UNITED STATES PATENT AND TRADEMARK OFFICE

APPLICATION NO.	FILING DATE	FIRST NAMED INVENTOR	ATTORNEY DOCKET NO.	CONFIRMATION NO.
10/796,811	03/09/2004	Barry T. Brinks	502724	2081

Office Action Summary

DETAILED ACTION

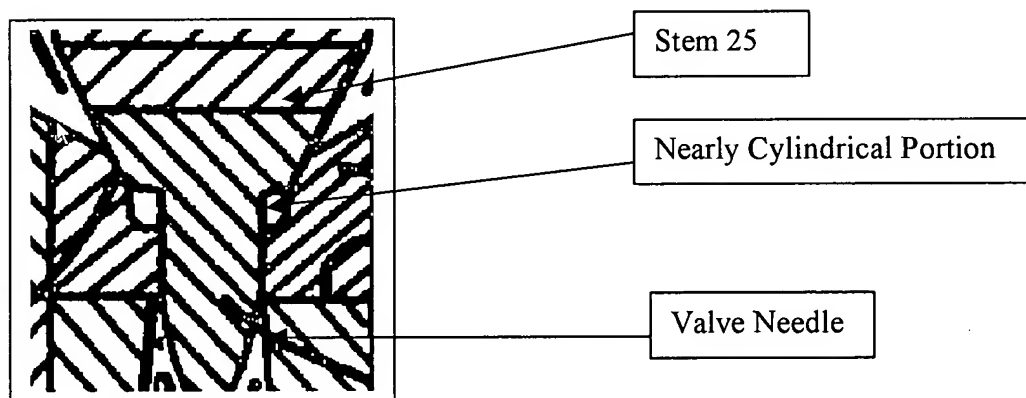
Applicants' also argue that the "step" of Platt is not a "nozzle throat", the examiner disagrees. When performing a structural comparison of Applicants' claimed invention and Platt, the "stepped portion" of Platt anticipates the "nozzle throat" of Applicants' claimed invention.

Applicants' also argue that Platt does not disclose a curved contoured portion upstream of the nozzle, the examiner disagrees. The following figure was extracted from figure 1 of Platt and clearly shows a contoured restriction upstream of the nozzle in the nozzle area:
